Legends Resort & Casino

Bid Package 1 – Envelope

Addendum No. 02

Date: July 7, 2023

5 PROJECT ID MONUMENT SIGN

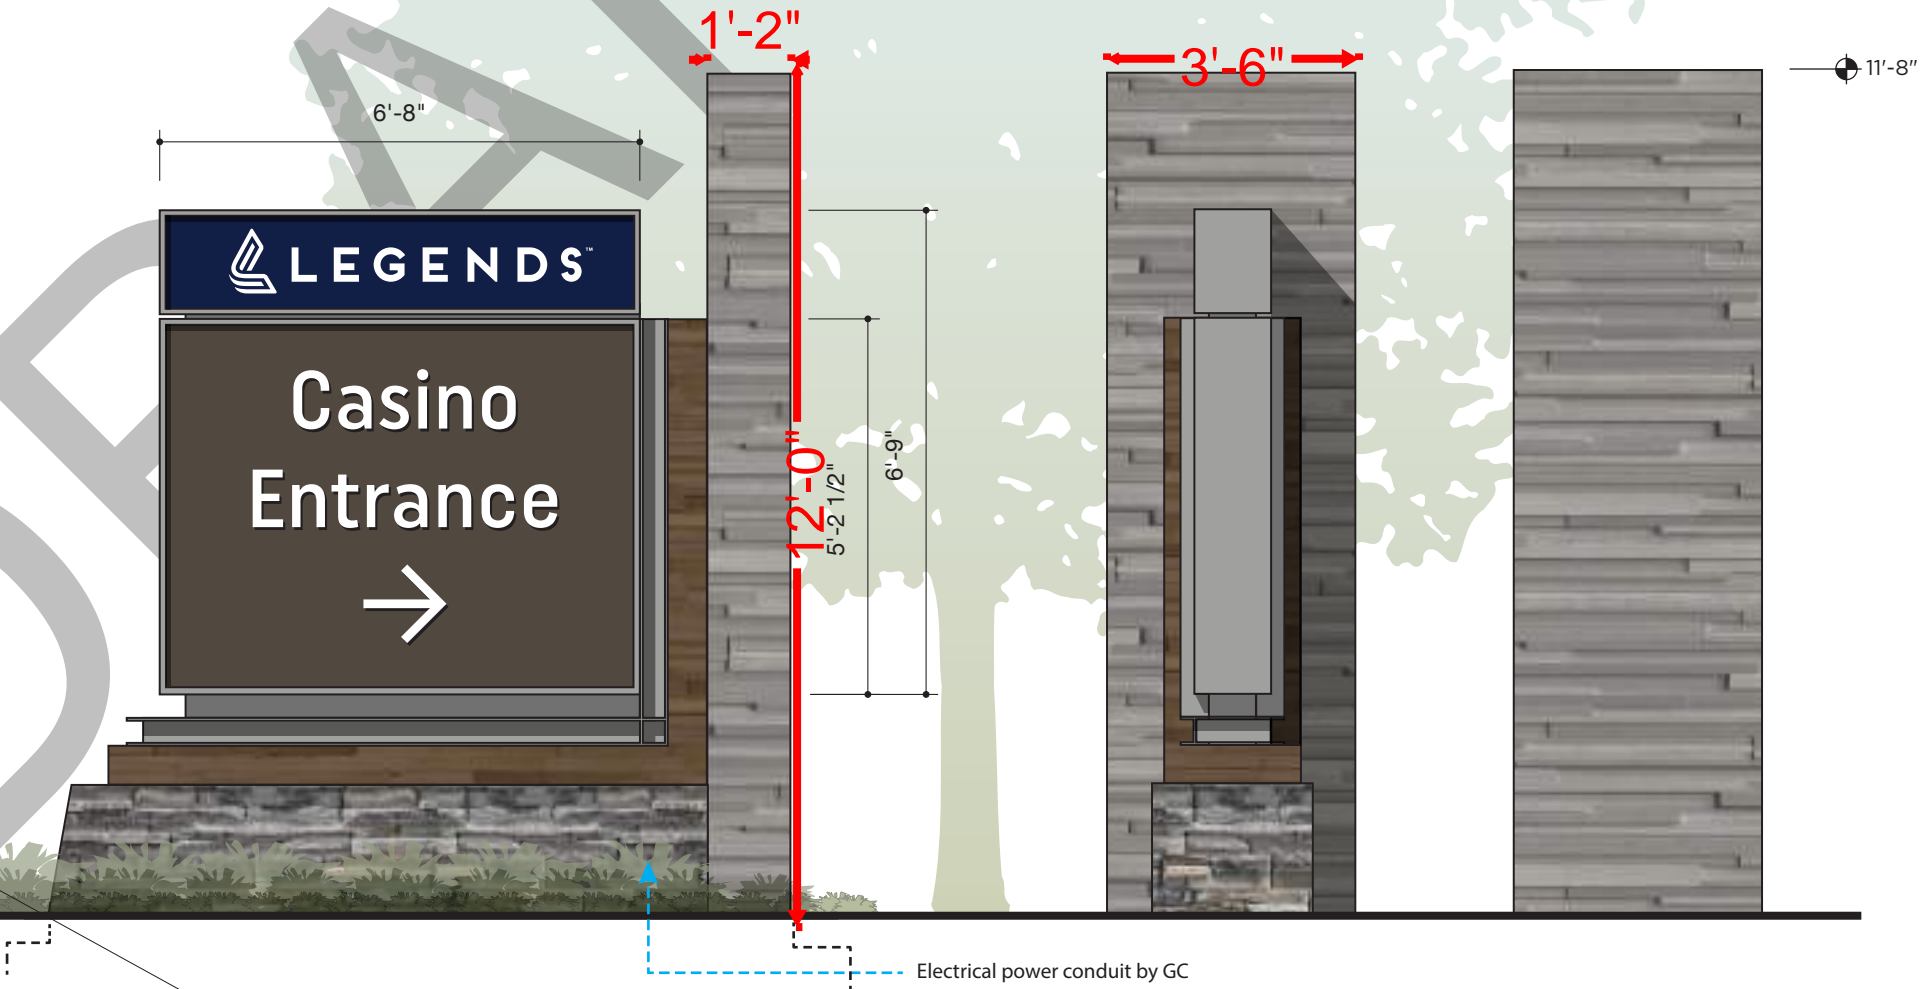
- 08) [Question] The 95% documents were issued on 06/07/23 after the issuance of BP1. During the review of the 95% documents, CDI found notes in the signage package that GFRC cladding is required at several outdoor monument-type sign locations such as signs "4", "4b", and "5" that are not indicated on the current architectural or landscape drawings. Please review with the signage consultant and Legends/CNE and verify if GFRC cladding is required at these (3) sign locations. If yes, provide additional details on these assemblies and verify if any other location signage or miscellaneous independent outdoor locations require GFRC cladding.
[Answer] This question is with the design team and response is pending. See the attached documents issued as part of the 95% signage presentation labeled as "Appendix B". CDI has also revised the GFRC fabrication and exterior framing bid scope sheets to include allowances for furnishing and installing GFRC paneling at the three monument sign locations labeled "4", "4b", and "5". See CDI's dimension mark-ups on "Appendix B" for estimating assumptions for the monument signs.
